**RE: Office/Warehouse at
3831 Masthead St NE
Grading and Drainage Plan
Engineer's Stamp Date: 1/4/23
Hydrology File: D17D095A**

3831 MASTHEAD ST
ALBUQUERQUE, NM

CONCEPTUAL GRADING
AND DRAINAGE PLAN

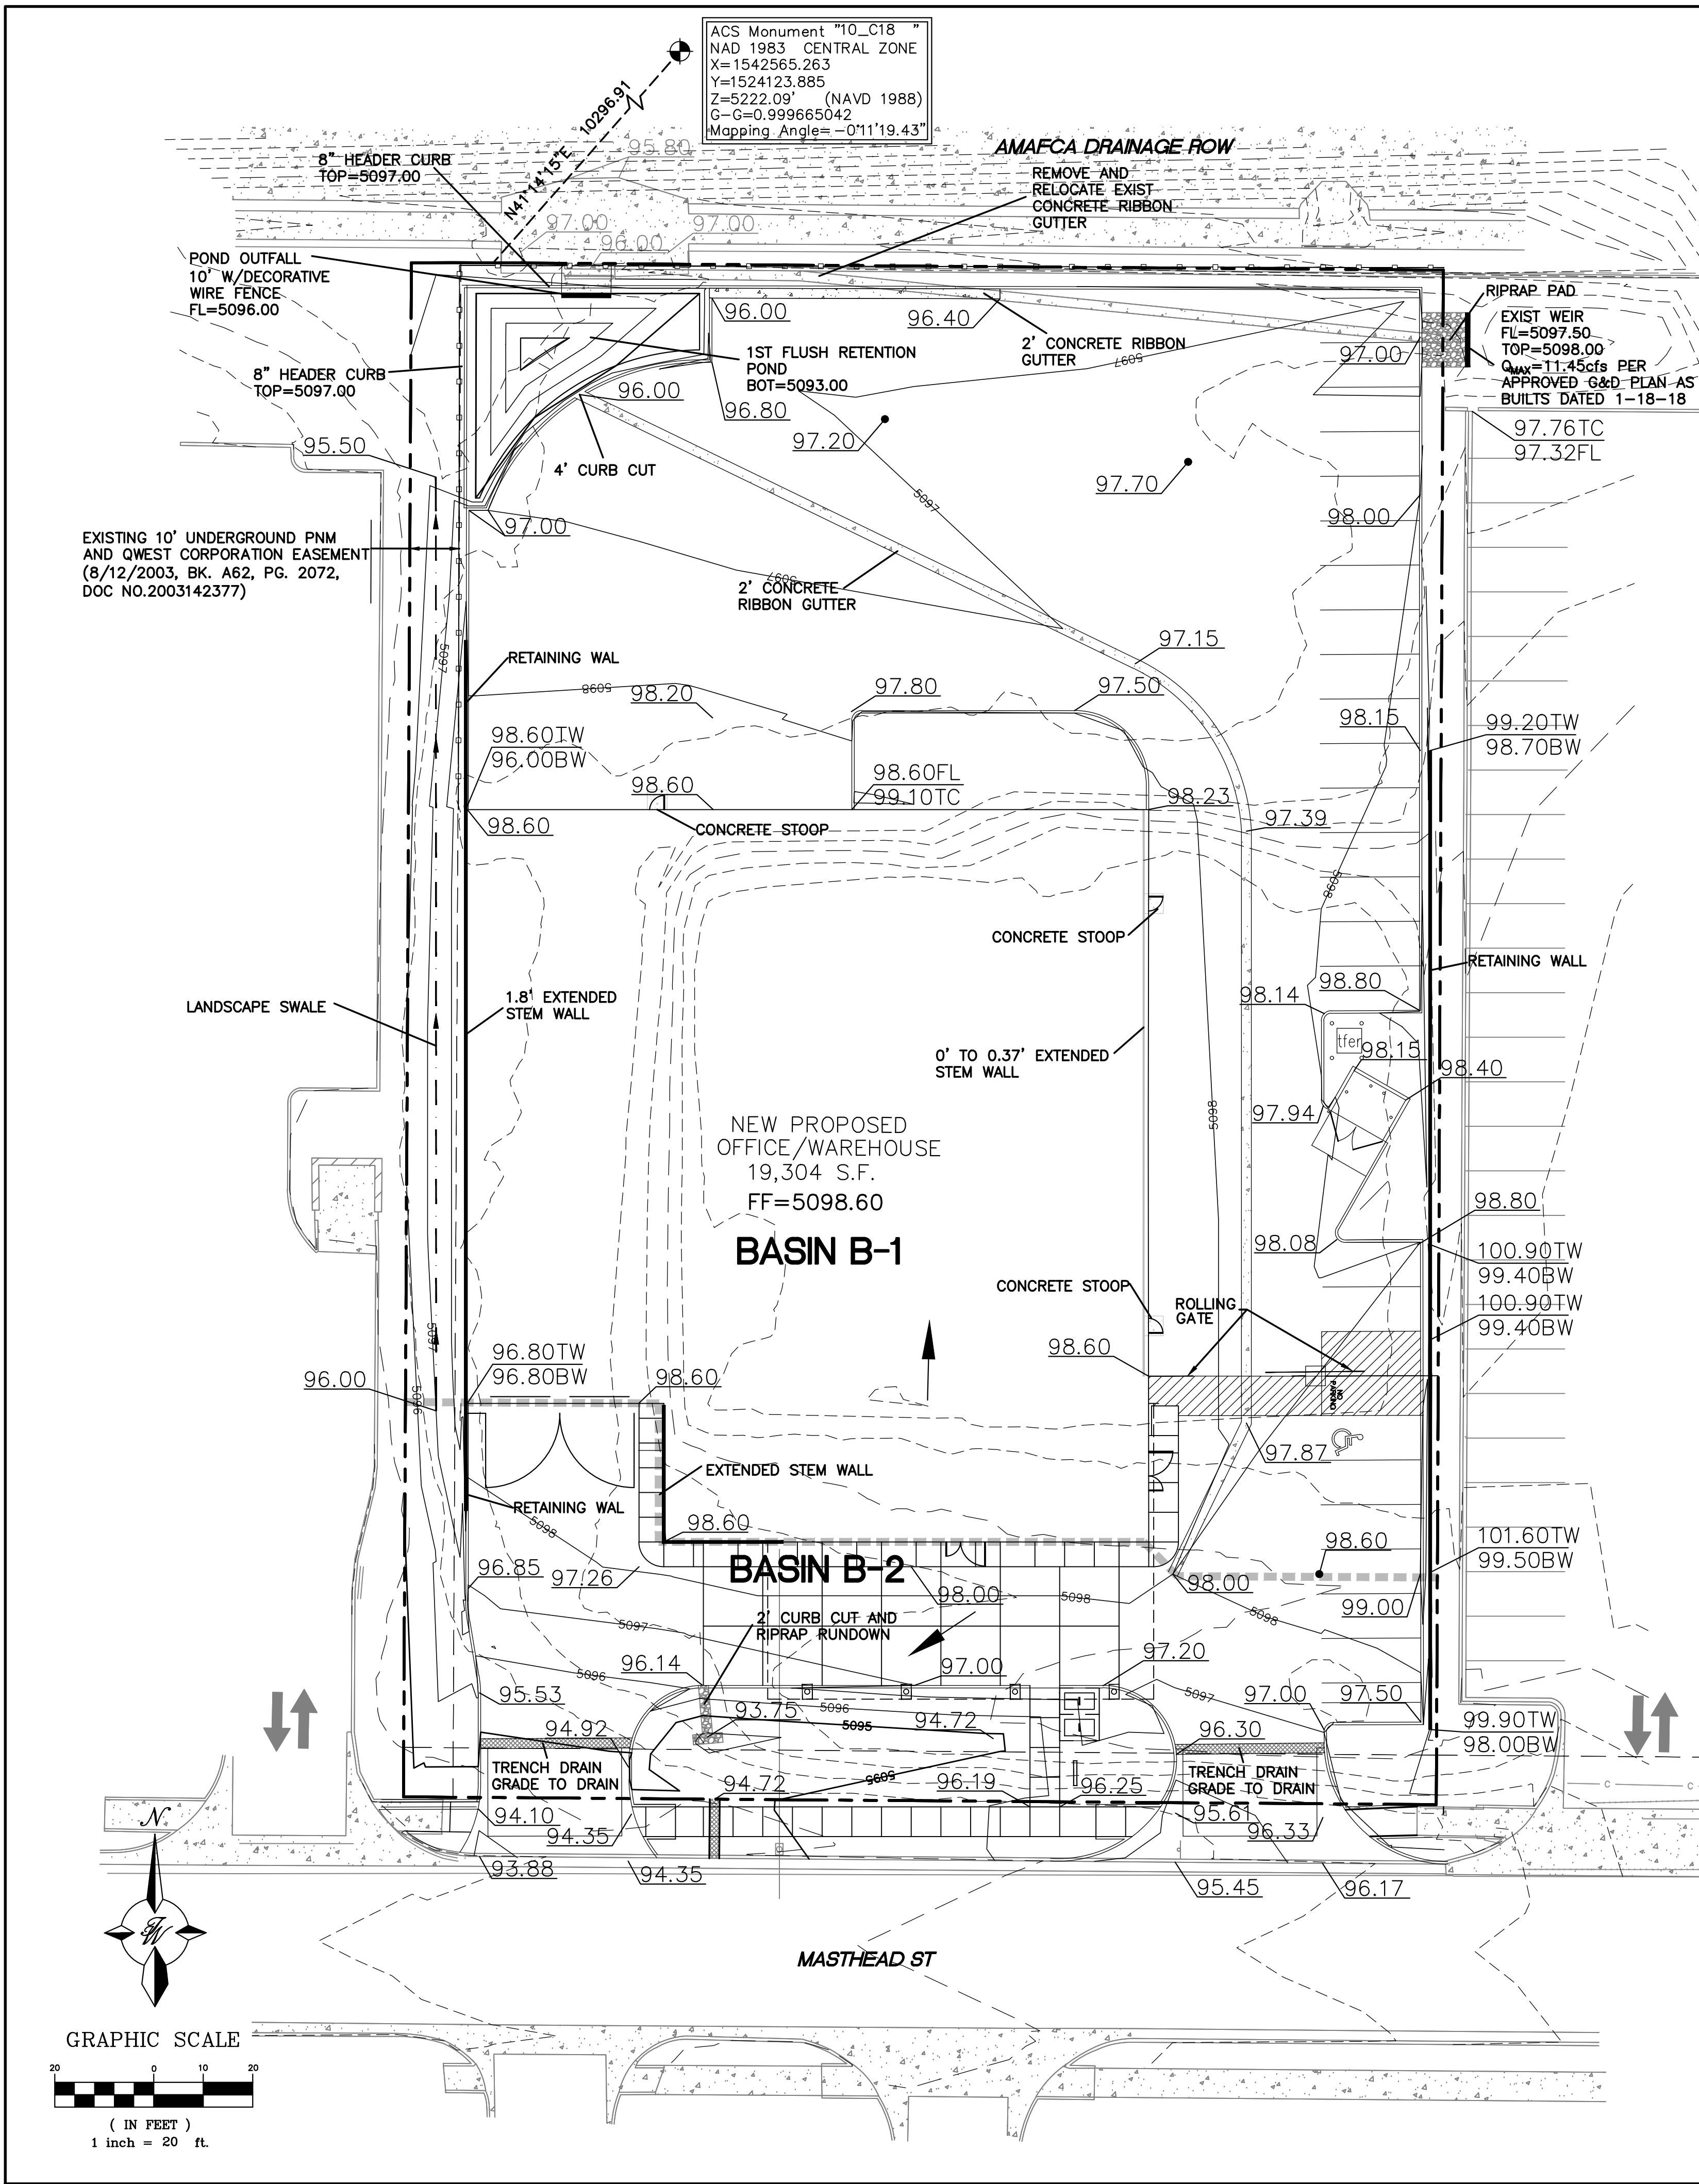
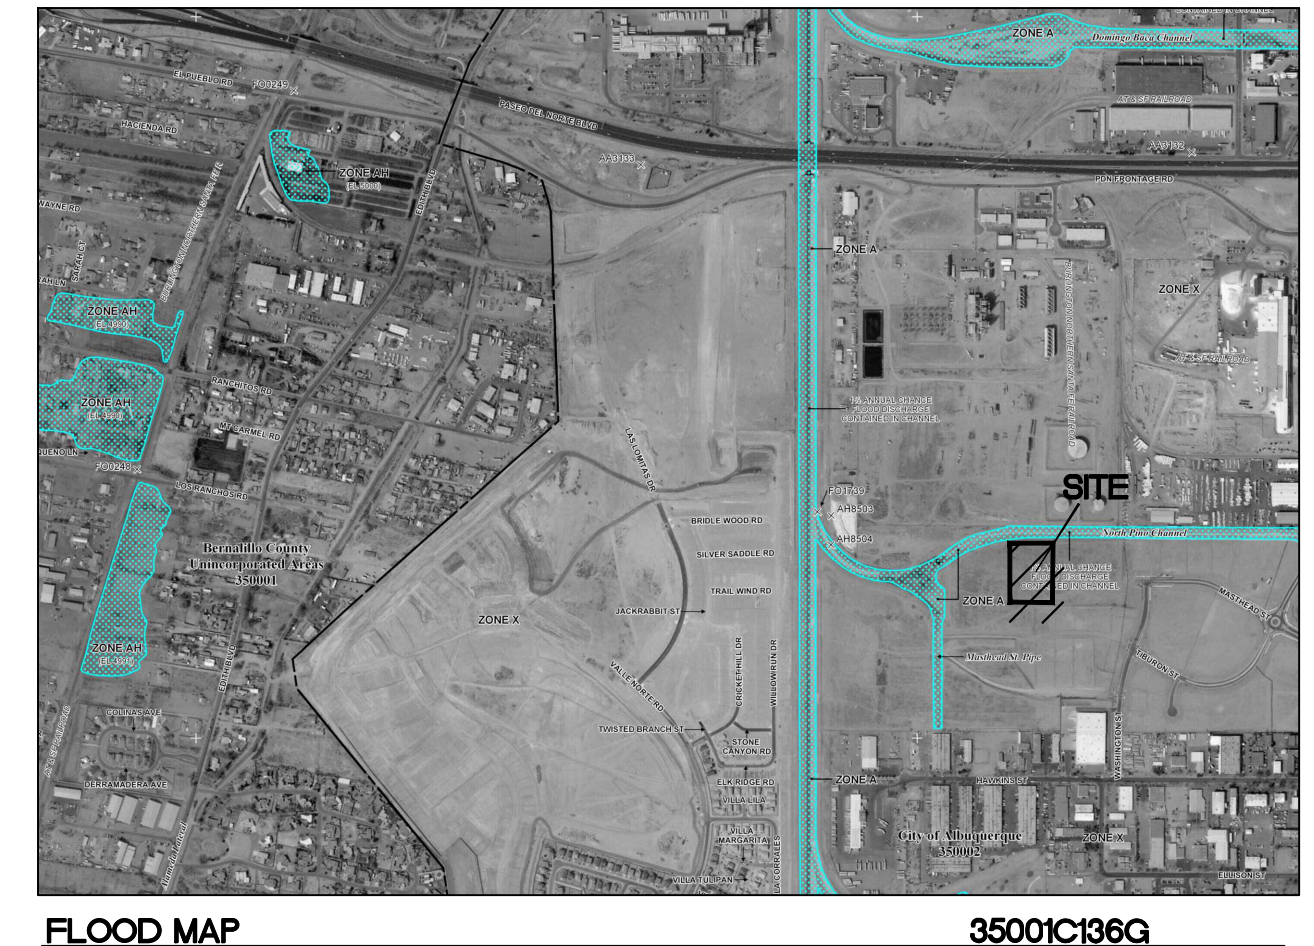
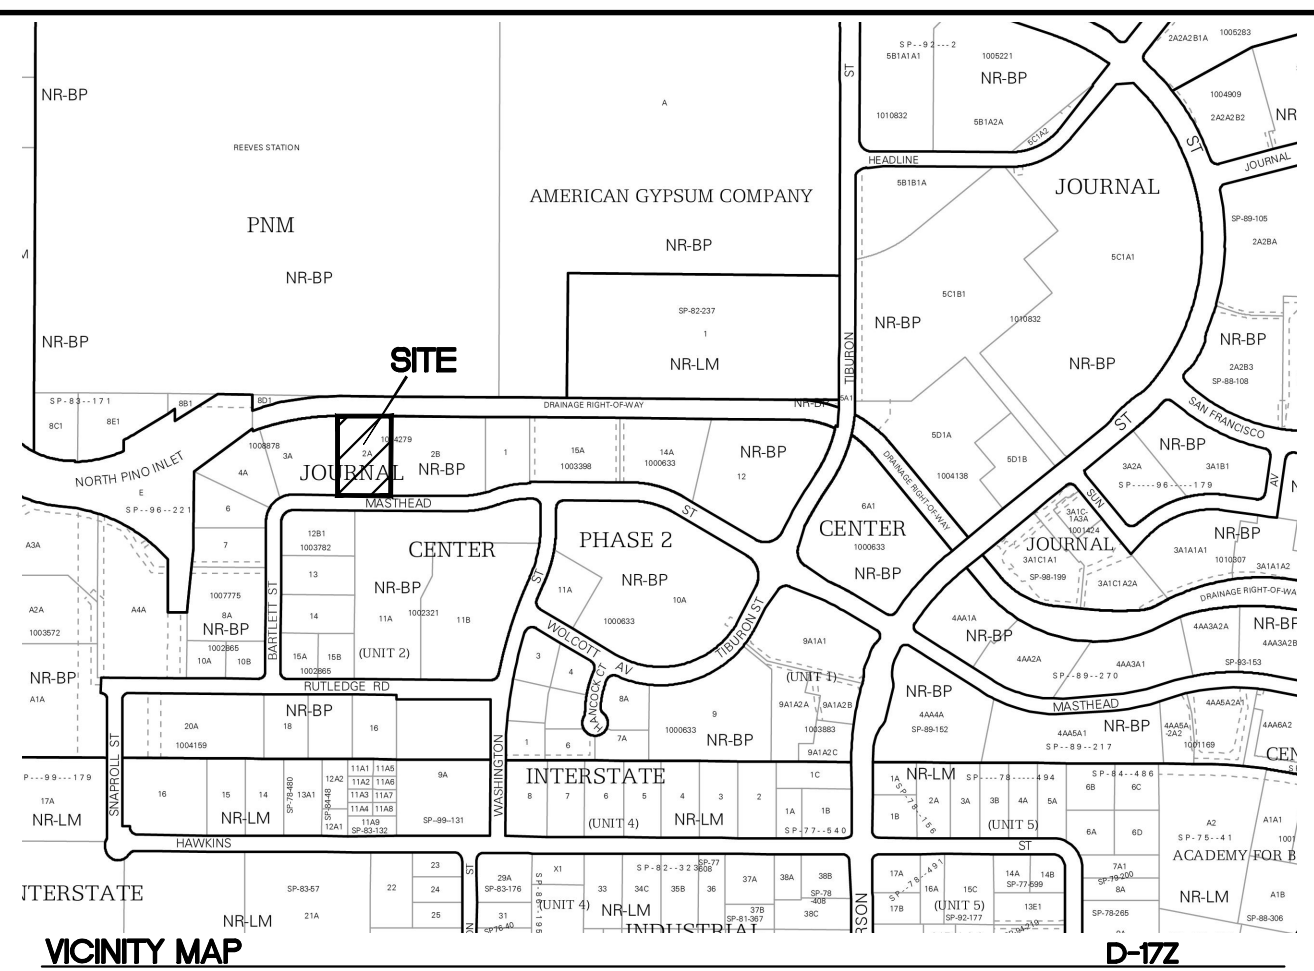
1. Since this project is adjacent to, and drains into an Albuquerque Metropolitan Arroyo and Flood Control Authority (AMAFCA) facility, approval by AMAFCA will be needed prior to Hydrology approval. Include all plans and specifications required by AMAFCA in this Grading Plan unless AMAFCA requires infrastructure in their right of way, in which case an infrastructure list and work order plans will be required. Please contact Jared Romero P.E, CFM (jromero@amafca.org or 505-884-2215).

2. Identify the offsite basin that flows through the North Pond. Those offsite properties must also be identified as the beneficiaries of the cross lot drainage easement.

3. Show Cross Lot Drainage Easements on the Grading & Drainage Plan specifying the beneficiary and maintenance. If an easement doesn't already exist then one will have to be granted.

4. Label both ponds with a construction note that specifies the pond bottom elevation, First Flush elevation and volume, spillway elevation and volume, 100 year elevation, top elevation. Include a detail with construction specifications of the outlet structures with a plan, profile, and section view. Resolve the discrepancy between the 8" header curb on the plan view of the north pond and the 12" depth of the outlet structure section (Is there a transition? If so, where?) Walls around that pond should be imbedded deep enough to prevent undercutting by hydrostatic pressure and backfill should be compacted to 95%. Include sections and specifications for the walls/curbs.

5. Identify non-erosive rundown structures into the north pond. Include hydraulic calculations for the pond inlet structures that account for the backwater effect of the pond outlet structure. Use this elevation to show the limits of the 100 year elevation in the

parking lot. Typical weir coefficients in HEC-RAS are 3.0 in English units and 1.66 for SI units.

6. Provide specifications for stabilization of the pond side slopes.
7. Add construction specifications for the South Pond spillway. Additional header curb may be needed west of the outlet structure if sidewalk and driveway elevations are below either the 100-year elevation or pond top elevation. An SO-19 Permit will be required and should be included on the request. Please include the standard SO-19 notes on the grading plan.

8. Provide the Benchmark information (location, description and elevation) for the survey contour information provided.
9. Provide sections through all external boundaries showing proposed retaining walls, garden walls, property/ROW lines, existing and proposed grades. In accordance with DPM Ch.22, section 5 part B, grading and wall construction near the property line may not endanger adjacent property or constrain its use.

- Show the amount of freeboard from the North Pino channel (assuming supercritical flow) to the site.
- Add a detail for the concrete ribbon gutter. Verify that it has the capacity to convey the flow (11.45 cfs) from the WQ pond to the east.

- According to the approved plan for the warehouse to the east, the water from the existing WQ pond is planned to spill over into this lot (see attached as-builts). You will need to accommodate that flow entering this site and routing to the existing rundown to the channel. There may need to be a cross lot drainage easement granted as a result of that flow crossing the lot to the rundown. **Runoff from the existing adjacent pond overflow will be accommodated in the development of this site. The runoff will be conveyed to the proposed first flush pond and into the existing AMAFCA rundown into the North Pino channel**

- You will need to provide an analysis of the existing North Pino channel and confirm that the 100-year WSE of the channel will not impact the proposed on-site drainage improvements. The 100-year flow rate for the North Pino channel at this location is 2,700 cfs. AMAFCA has recent topographic information for this arroyo if requested. **See attached analysis results of North Pino channel for confirmation of the 100-year WSE. We used the survey and flow rate information you provided. In viewing the results of the analysis, we raised the finish floor elevation to be a minimum of 2' above the WSE for the 100-year design storm.**

- Provide a calculation on the proposed discharge from the WQ pond above the first flush WSE to the existing rundown. Confirm that the existing rundown is sized for the proposed discharge to the channel and identify any improvements that would be needed to connect to the existing rundown. **Calculation shown on revised grading plan verifies the 10' pond outfall has capacity to handle the flows from the design storm.**

- What is the hatching identified in the pond and on the perimeter of the lot? Also, the proposed grading does not show a clear flowline from the pond to the existing rundown and shows the pond outfall elevation at 5095 and the invert of the rundown at 5096. **The hatching was meant to delineate landscaped areas. It has been removed from the G&D sheet. A concrete rundown/channel has been added from the pond outfall to the existing North Pino Channel concrete rundown.**
